Re: Maifly Development -5 Freese Road
SWPPP and Utility Review

We have received an electronic copy of the project drawings sheet C-1.0 through C7.0 dated October 16, 2020 along with a copy of a conceptual SWPPP dated August 19, 2020 for the above referenced project. These documents were prepared by Marathon Engineering. I have completed a review of the documents for compliance with Town regulations and offer the following comments:

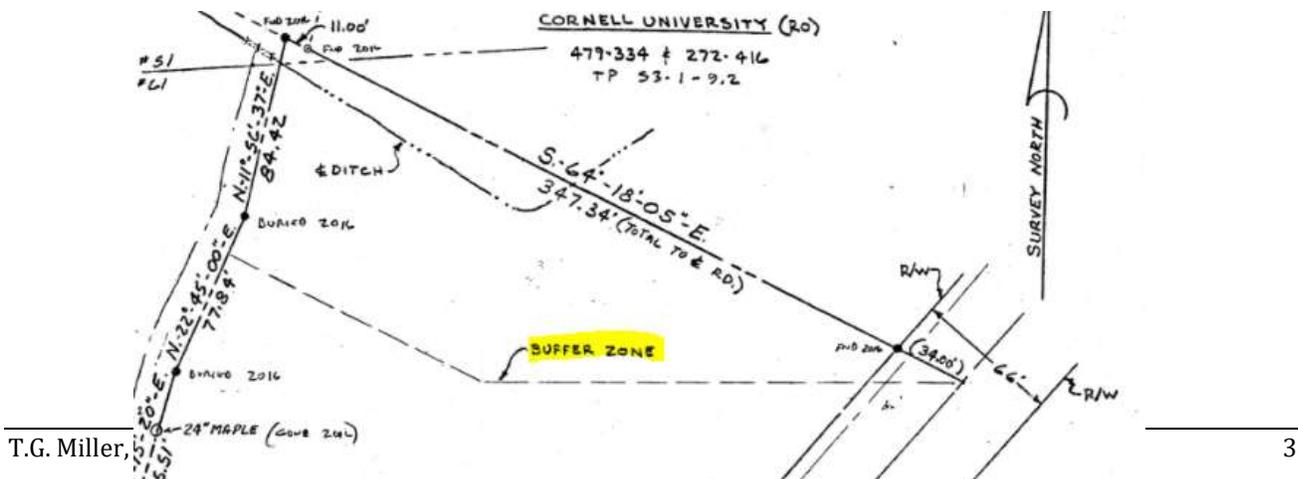
8. Add note to rework existing sanitary manhole and pour new invert and at the new along Freese Road.
9. Include Town sewer specifications on plans. See attached. Revise details accordingly.

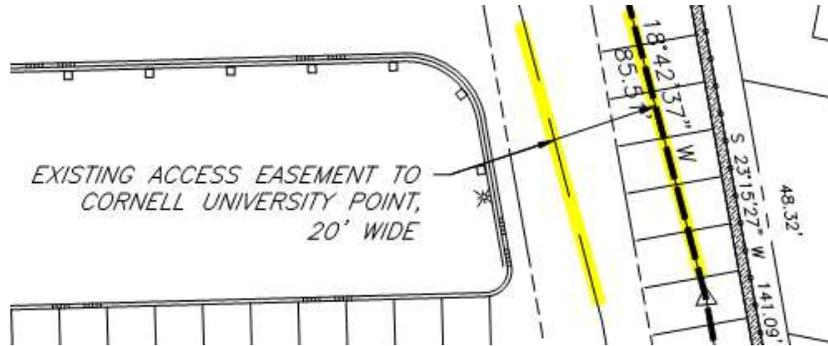
9. Are there any existing landscape buffer easements with Cornell at the northeast corner of the property that need to be maintained? See image below.
